**DOCKET ITEM #5**  
**Master Plan Amendment #2018-0008**  
**Text Amendment #2018-0014**  
**CDD Concept Plan #2018-0006**  
**Development Special Use Permit #2018-0002**  
**Potomac Yard Landbay H West - Silverstone**  
**2602 Main Line Boulevard**

Application	General Data	
<b>Project Name:</b> Potomac Yard Landbay H- West Silverstone	PC Hearing:	November 8, 2018
	CC Hearing:	November 17, 2018
	If approved, DSP Expiration:	November 17, 2021 (three years)
	Plan Acreage:	87,810 SF (2.01 acres)
<b>Location:</b> 2602 Main Line Boulevard (2600 & 2606 Main Line Boulevard)	Zone:	CDD #10 / Coordinated Development District #10
	Proposed Use:	Home for the Elderly (Assisted Living and Memory Care and Retail – Building 1; Independent Living – Building 2)
	Dwelling Units:	146 units (Building 2)
	Net Floor Area:	185,343 SF (Building 1) + 150,558 SF (Building 2) = 335,901 SF total
	Small Area Plan:	Potomac Yard/Potomac Greens
<b>Applicant:</b> Silverstone Alexandria, LP c/o Silverstone Senior Living represented by M. Catharine Puskar, attorney	Historic District:	Not applicable
	Green Building:	LEED Silver or equivalent
<b>Purpose of Application</b>		
The applicant requests approval of a Master

***Graphic F: Building #1 – Revised SW Elevation per PYDAC Comments 10.5.2018***

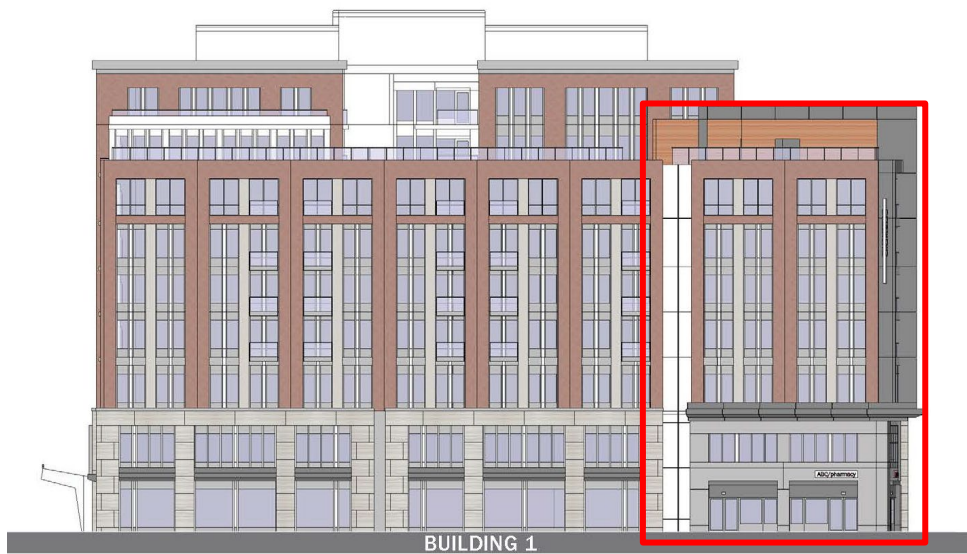
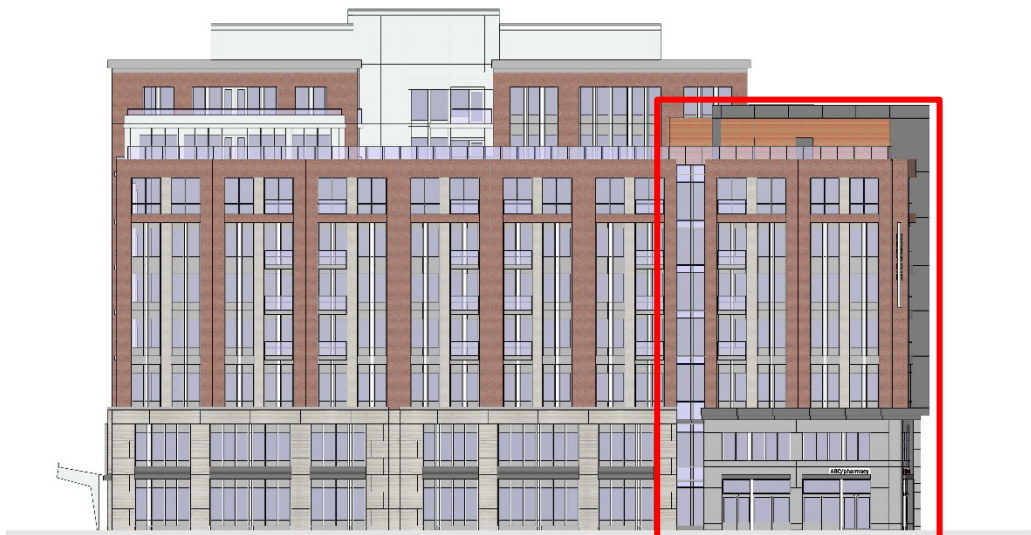
During their review at their June 27<sup>th</sup> meeting, PYDAC made a couple of design recommendations regarding the general direction of the building and side design. Following the June meeting, the applicant design team worked with staff to refine the building design, form, materiality and proportion and presented updated drawings at the September 19<sup>th</sup> meeting. During this meeting PYDAC conveyed overall support of the evolution of the building and site design however, requested the applicant continue to rethink the material selection of the building seam and revise the southern elevation and retail corner of Building 1. Additionally, PYDAC requested the applicant and staff provide contextual exhibits relative to the site. The applicant responded to the PYDAC design comments as shown in Graphic F & H, incorporating spandrel glazing at the building seam,

increasing the window proportion and material selection and the retail corner, and rethinking the material selection and design of the center massing on the southern elevation of Building 1. Additionally, the applicant provided a photomontage exhibit, as requested by PYDAC, to show the proposed buildings in context with the adjacent buildings to the north and south (Exhibit D).

15. Comply with the following guidance for Building 1 (South building)
- a. The expressed seam on the west elevation shall be detailed such that the spandrels read as continuous with and as similar to the vision glass as possible as depicted in Graphic F. Continue to work with Staff to refine materials selection and details though the Final Site Plan.
